West Capital Airpark Phase 1B-2 Residential (Novatech Phase 2B) Stormwater Management Report

**West Capital Airpark – Phase 1B-2 Residential
1500 Thomas Argue Road
Ottawa, Ontario**

**Reference: West Capital Airpark – Phase 1B-2 Residential
Stormwater Management Report
1500 Thomas Argue Road, Ottawa
Our File No: 102085
City File No.: D07-16-22-0017**

This report has been revised to address comments from the City of Ottawa as indicated in the cover letter. The City review comments and response to comments are included in **Appendix A** for reference.

PROJECT No. 102085
REV # 8
DRAWING No. 102085-SWMF5

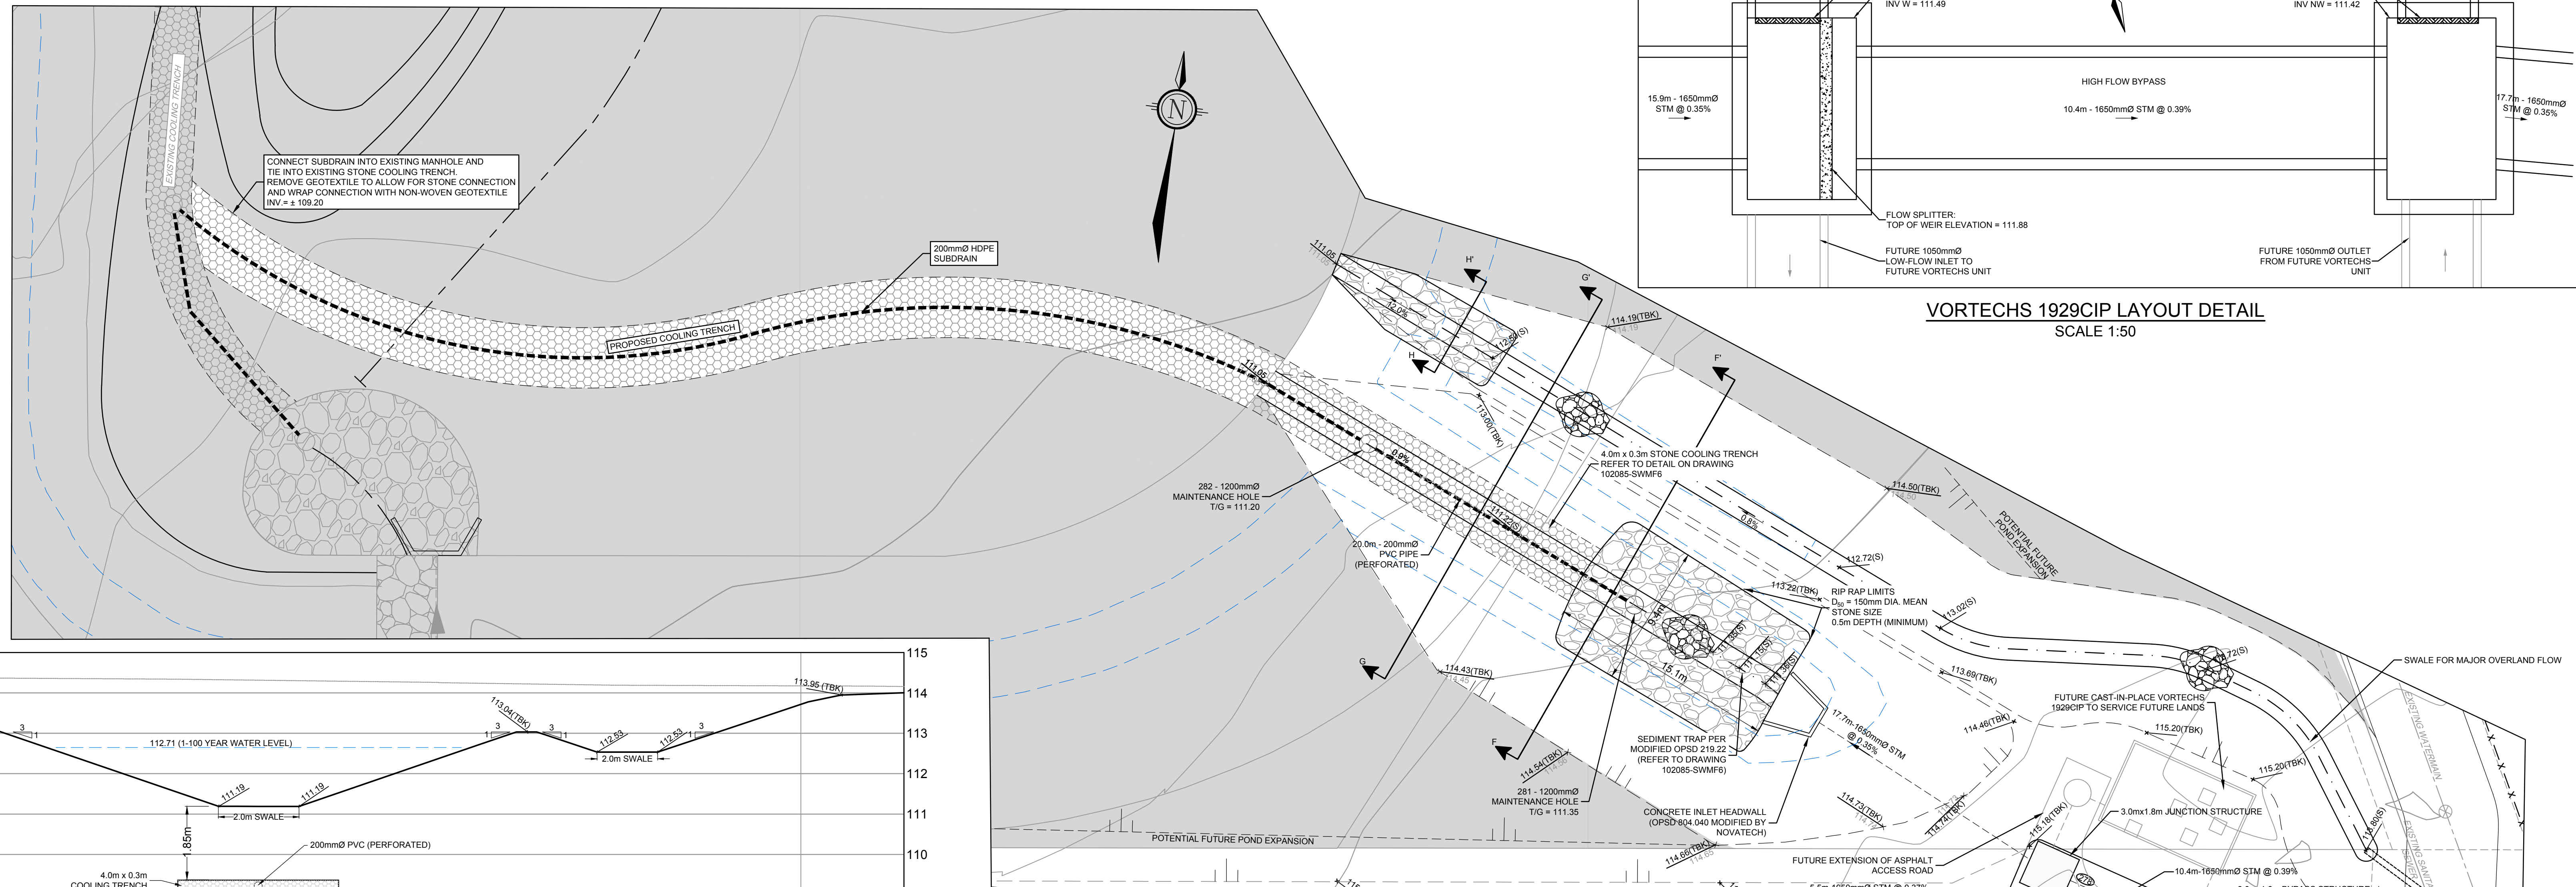
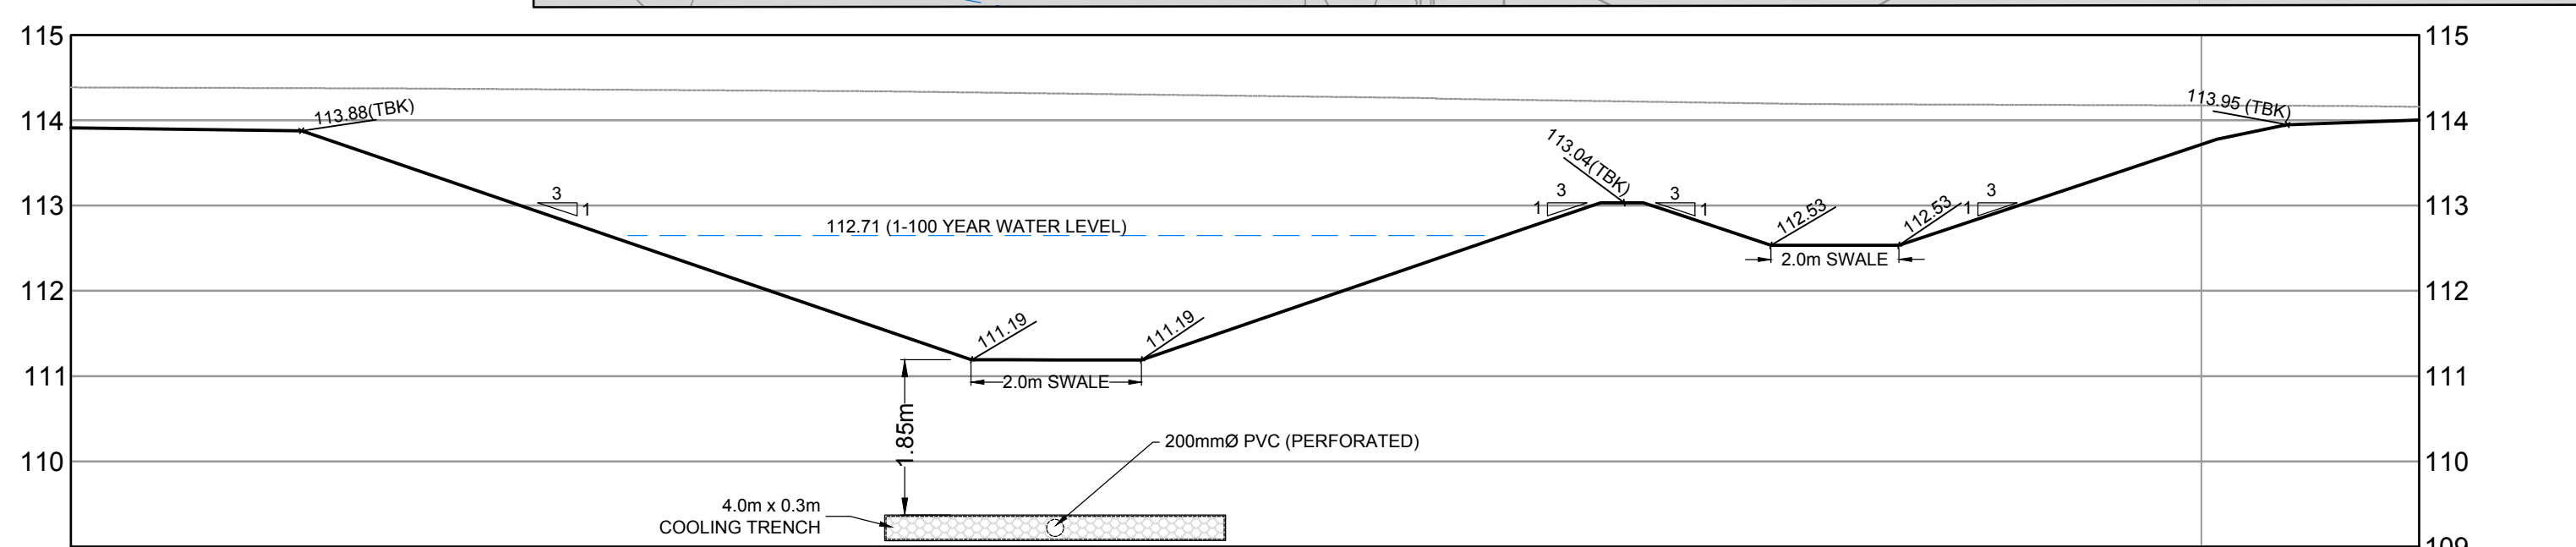
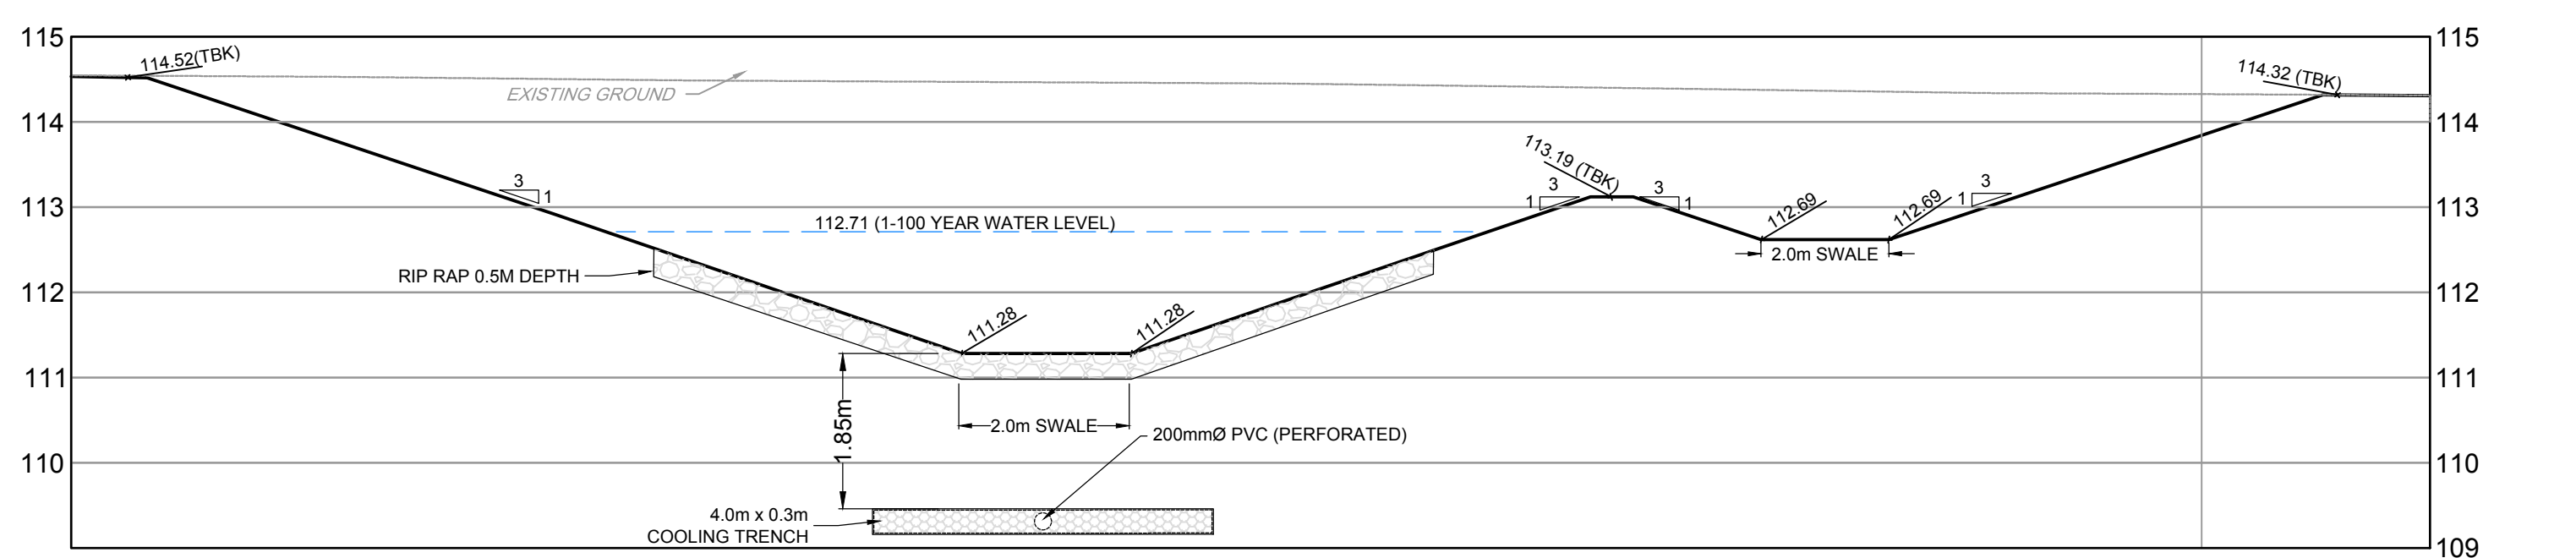
4	Riprap swale design details should include length of riprap areas on either side.	Pond Inlet & RipRap			This information has been added to the drawing 102085-SWMF5.	
5	Are clear stone fillings of rock check dams within infiltration swales provided to the top of the bank of the swale, without any freeboard?	Ponding			Refer to drawing 102085-INF2 for updated details of the rock check dams. As the runoff originates from the undeveloped lands, freeboard is not provided on the undeveloped side of the swale.

15	SWMF5, provide inverts on the proposed offline exfiltration, provide inverts on Vortechs, provide details of the flow splitter upstream and downstream of Vortechs, Provide confirmation from Vortechs that the downstream weir will not affect the function of the OGS.	General			The offline exfiltration trench and the weir in MH 277 have been removed. Refer to the Vortech 1929CIP Layout Detail on drawing 102085-SWMF5 for details.	
PCSWMM Modelling						
1	There are minor discrepancies regarding the size of the pipes in the PCSWMM. Please revise the size of the pipe as required. (ex.: between MH269-MH270- drawing 675mm, PCSWMM 686mm).	General			Actual pipe sizes were used in the model instead of nominal pipe sizes.	
2	It seems that the infiltration ratio is calculated per the location of the trenches. Please provide rationale and/or calculation results regarding infiltration ratio into subsoil for the rear yard infiltration trenches, roadside exfiltration trenches, and an offline exfiltration trench in PCSWMM.	LIDs			All infiltration measures have been removed from the PCSWMM model. Rear yard pipes are assumed to be full for modelling purposes.

4.	Riprap swale design details should include length of riprap areas on either side.	This information has been added to the drawing 102085-SWMF5.	The rip-rap swale details provided on the 102085-SWMF-5 drawing are assumed to be general one and shall refer to the location where external flow through the swale occurs. Is the channel section between E-E and the headwall the same as E-E with the exception that it contains rip-rap? Please clarify.
